Release note

Dual Lens Tracking Camera: TR535/ TR535N

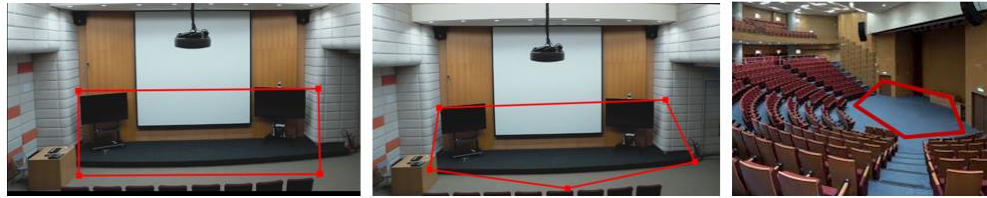
Note: All five angles of the pentagon must be convex (outward), and none of them can be concave (inward).

✓ **correct setting**

✗ **Incorrect setting**

4. Improved System Recovery Mechanism

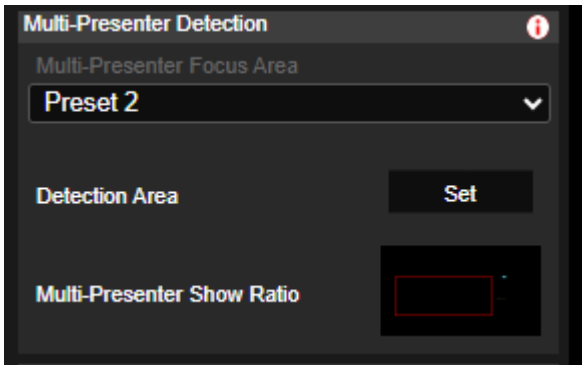
Added VISCA command to restart the HTTP server, allowing remote recovery in cases where web UI or API access becomes unavailable without requiring a full device reboot.

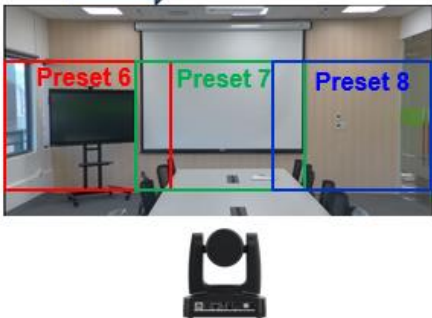
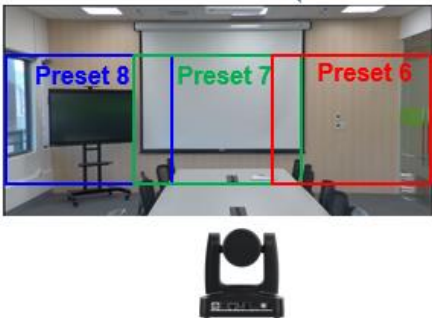
5. Added support for setting presets 6/7/8/9 in both directions on Zone Tracking, making it easier for users to configure and reducing the chance of setup errors.

Original: from left to right  Added: from right to left 
Known issue	1. We recommend using the Chrome browser for configuring webpages. 2. HTTPS: Enable HTTPS to establish a secure connection between the browser and the camera. To enable HTTPS, please follow the steps below. A. Obtain an SSL certificate in base-64 encoding format for encryption and decryption, and a private key in PKCS#8 format (must be unencrypted). B. Convert the required certificate content into PEM format. The SSL certificate uploaded to the camera must be in PEM format. C. In the HTTPS settings field, select "On", then click "Choose File" to select the certificate file, and then click "Upload". 3. The TR535 is not compatible with Mac O.S 11

Remote Control

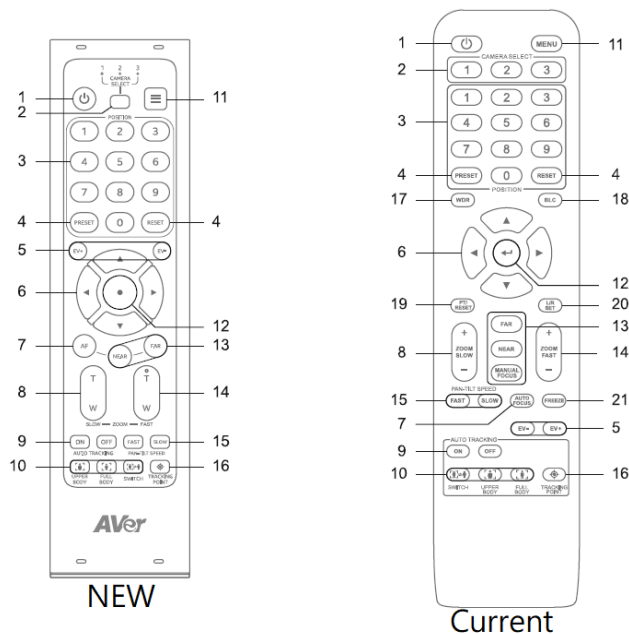
- Added "P/T Reset" and "Panning Direction (L/R Set)" to the Web Interface and OSD Manual to prepare for the new remote control rollout in Q2, we have added the "P/T Reset" and "Panning Direction (L/R Set)" options to the web interface and OSD manual. The new remote control features a simpler design, removing two buttons and relocating their functions to the web interface and OSD manual.

Both the current and new remote controls will be fully compatible with the camera. Please see the new remote control design below.

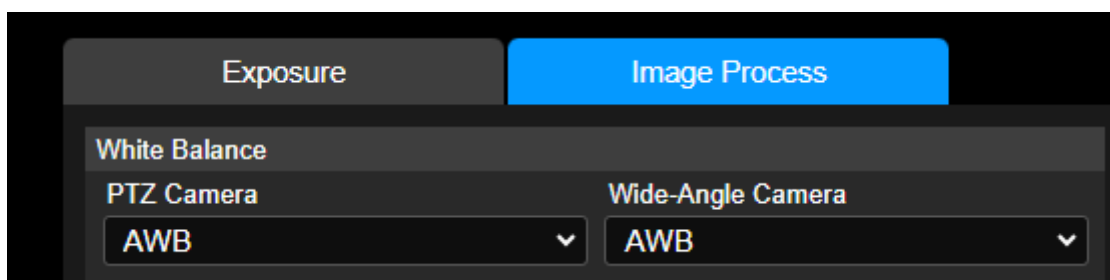
3. Bug fix: Correct the feature name from PIP to “PIP/PBP” on OSD menu.
